### 3. Revised Project Amendments

#### NEW ACLAND COAL MINE STAGE 3 PROJECT

#### Figure 3.1-A - Revised Project Amendment

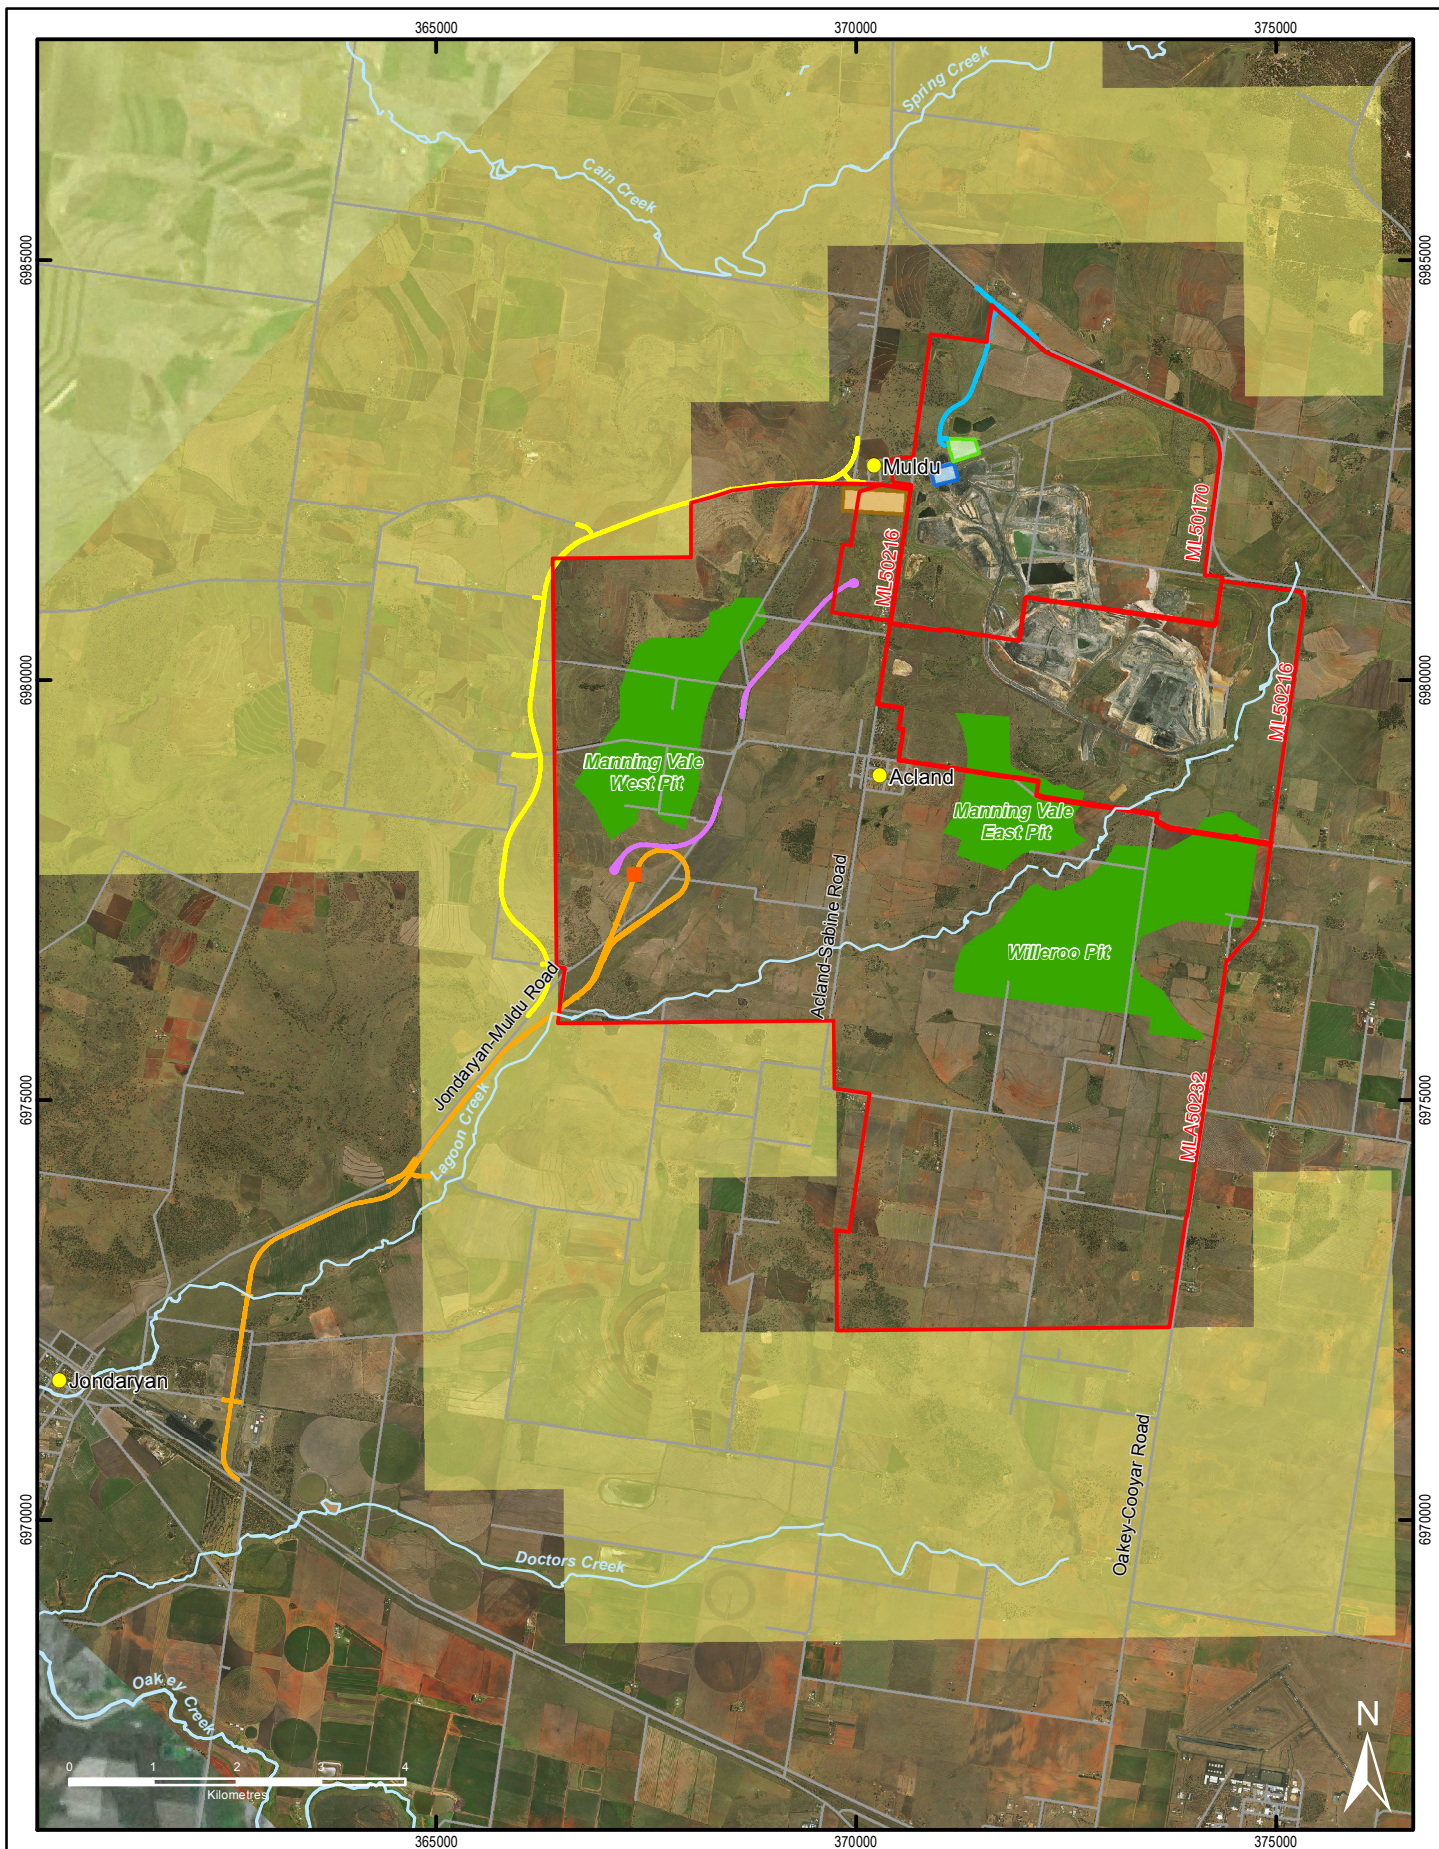
As a result of this phase, **Figure 3.1-A** depicts the revisions made to the main access to the mine, the alignment of the Jondaryan-Muldu Road and the alignment of the rail spur and balloon loop and location of the new Train Loadout Facility (TLF) for the revised Project. A description of the amendments to the revised Project is described in **Table 3.1-A**. In addition, the internal haul road from the Materials Handling Facility (MHF) to the new TLF will remain in place for the duration of the revised Project. Other internal haul roads used for the transportation and raw coal from the mine pit to the Run-of-Mine (RoM) Pad and light vehicle access will be periodically constructed in front of the mine path to allow for access and transportation of raw coal. These minor changes will not result in an increase in environmental nuisance or harm.

Revised Project Amendment Component	Description of Amendment to that described in draft EIS
Main Access to the revised Project	The original main access to the revised Project was along Cherry's Road to the north of the revised Project site. Feedback from the public consultation and the Department of Transport and Main Roads raised safety concerns with this road intersection. NAC revised this access and propose to construct a new road off the Peachey-Maclagan Road which will enter into the new Mine Industrial Area (MIA). The new road will be designed to the appropriate standards to transport light vehicles into the revised Project site.
Rail Spur and Balloon Loop and TLF location	The layout of the rail spur and balloon and location of the new TLF has changed as to that presented in the draft EIS based on the FEED phase. The amendment to the original alignment will now result in the new TLF being on the western side of the balloon loop as opposed to the eastern side. There will also be a slight adjustment to the alignment at the intersection of the Jondaryan-Muldu Road and Childs Road to meet rail design requirements. For additional information regarding this matter refer to <b>Section 5.1.3.2</b> of the AEIS.

Jondaryan-Muldu Road Diversion	The original alignment to the Jondaryan-Muldu Road will be slightly changed at the intersection of Cooke-McGovern Road and the Jondaryan-Muldu Road to minimise property impacts and accommodate natural drainage channels. The alignment will be moved to the east by approximately 200 m. In addition, the alignment near Muldu will join the Muldu-Plainview Road north of the revised Project site.
